SUNDRY NOTICES AND REPORTS ON WELLS

8. FARM OR LEASE NAME
AXI Apache C

TITLE Proposed P & A Sketch
AXI Apache C #1

Attachment to Notice of
Intention to Abandon

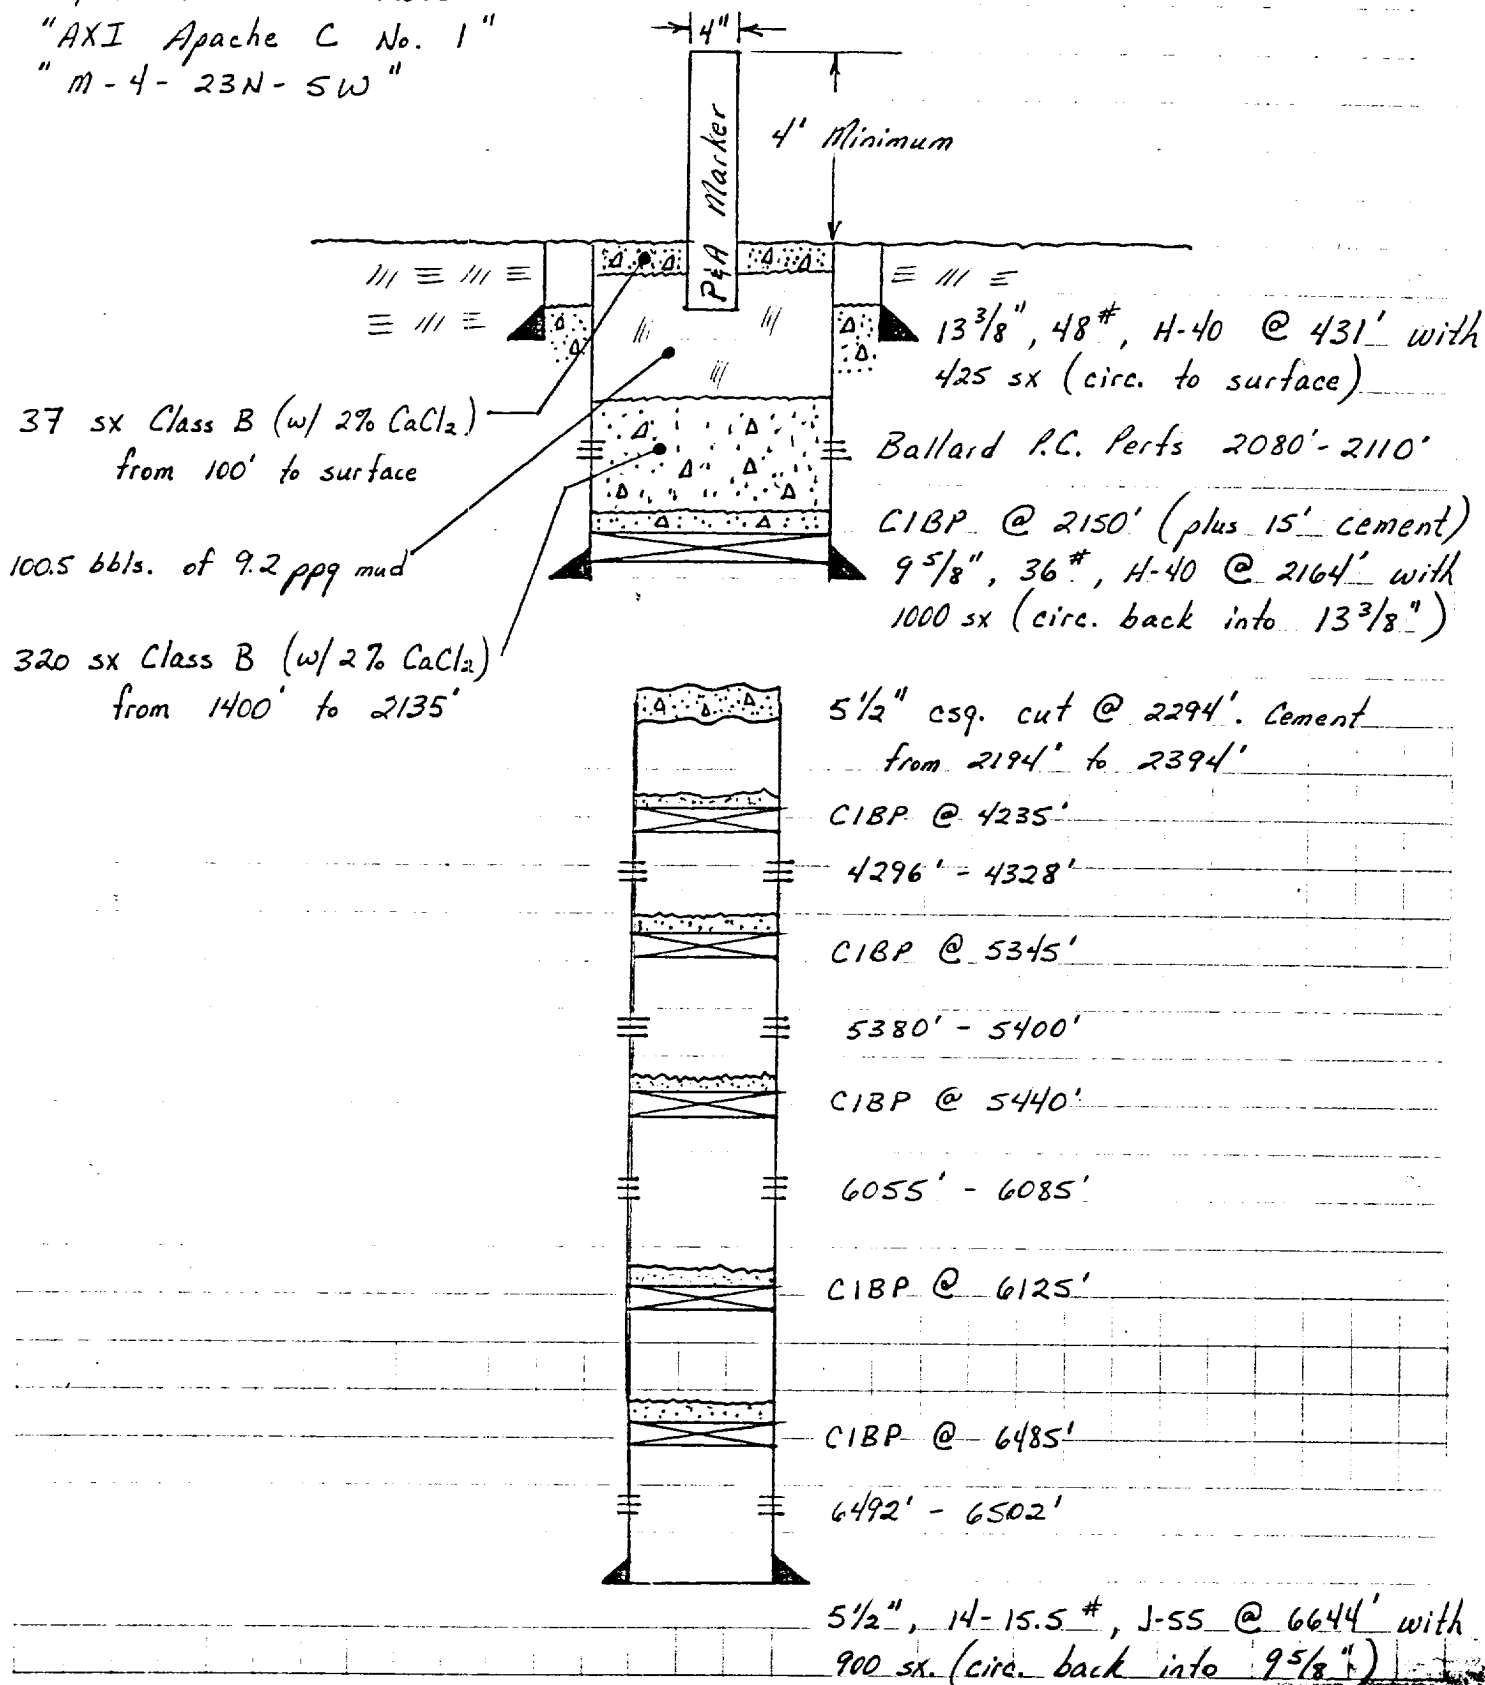
APPROVED
AS AMENDED

P & A Marker includes:
 "AXI Apache C No. 1"
 "M-4-23N-SW"
